**PLANNING RATIONALE REPORT : ZONING BY-LAW AMENDMENT APPLICATION**

**1765 MONTREAL ROAD AND 9 BECKENHAM LANE  
17 STOREY AND 6 STOREY, 325 UNIT APARTMENT  
LANDRIC MTL ROAD INC/LANDRIC HOMES INC.**

**PREPARED BY: P H ROBINSON CONSULTING  
APRIL 2025**

**1765 Montreal Road** | Informal Pre-Consultation Review | Site Plan Control & Zoning By-law Amendment | Project1 Studio, Novatech and P.H. Robinson Consulting |

1 SITE PLAN  
SCALE: 1:200

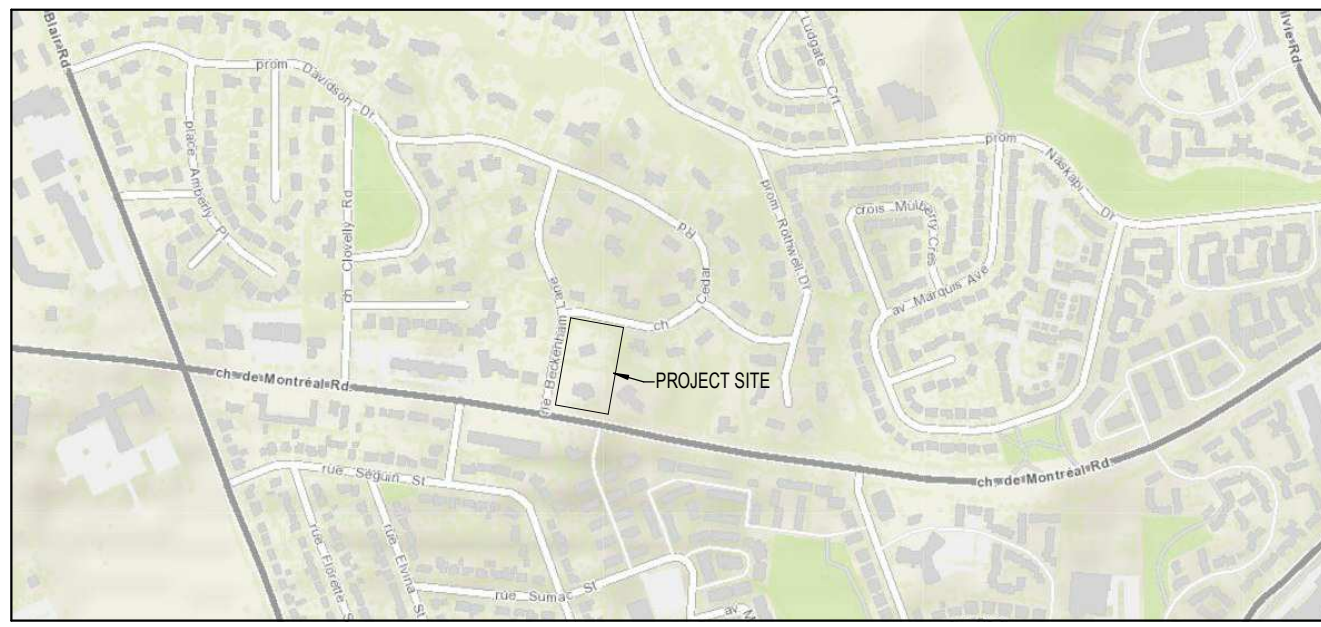
- Consider consolidating access points to minimize vehicular circulation around the site and integrating parking garage as part of phase one.
  - The Panel suggests exploring an access point on the ground floor for the units in relation to the park to provide an option for units to be accessed either directly from grade or from the corridor. This would have the added benefit of screening the blank wall on the lower level facing the park.

- Consider eliminating or relocation of surface parking to enhance green space and mature tree preservation.
- The Panel appreciates the symmetrical site plan but suggests exploring a less rigid and formal symmetry of the landscape courtyard.

- The symmetrical garden design could be modified to allow for a more organic flow and additional green space, contributing to the overall livability of the development.

The Panel recommended simplifying the parking layout to streamline entering and exiting the underground parking garage. The site accesses were not changed due to grading constraints and proximity to the Montreal Road / Benckenham Lane intersection. The Panel also commented on the architectural articulation of the towers and the podiums indicating that they compete with each other. In response, the design team incorporated tower elements at the podium level in key locations to strengthen their connection. The Panel's comments regarding the interaction between soft landscaping and the buildings were taken in consideration.
